Subject: Field Repair Notice 817-2: Model 337 DPF/SCR Mount Bolt Torque

**817-2**

Model 337 DPF/SCR Canister Bracket Bolts may be under-torqued.

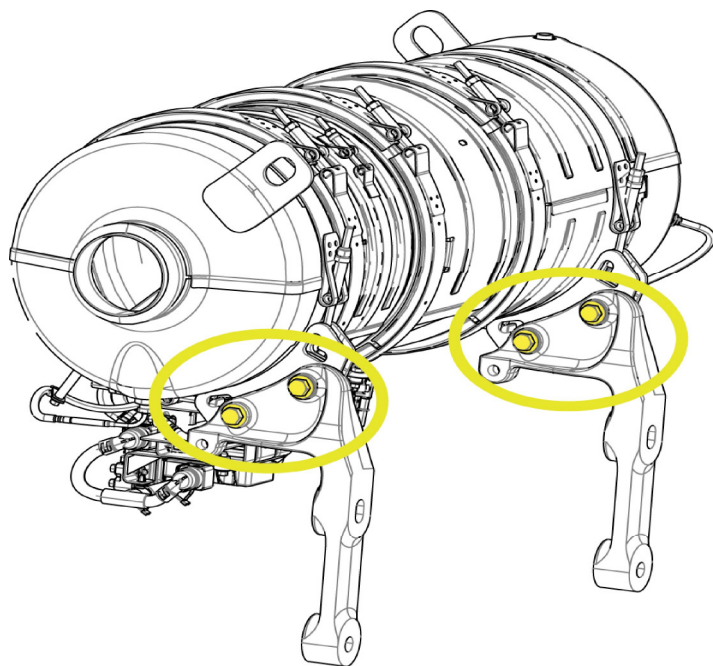
Peterbilt has determined that certain Model 337 vehicles built between July 27, 2017 and July 31, 2017 may have DPF/SCR bolts that may not be properly torqued.

1. Inspect the bracket bolts, nuts, and washers (noted within the yellow circles) for damage. If damage to any of the bolts is found, replace the parts using the table above.

2. Torque the four bracket bolts that attach the DPF/SCR Canister to 55-70 lb-ft. (74.5-95 N·m).
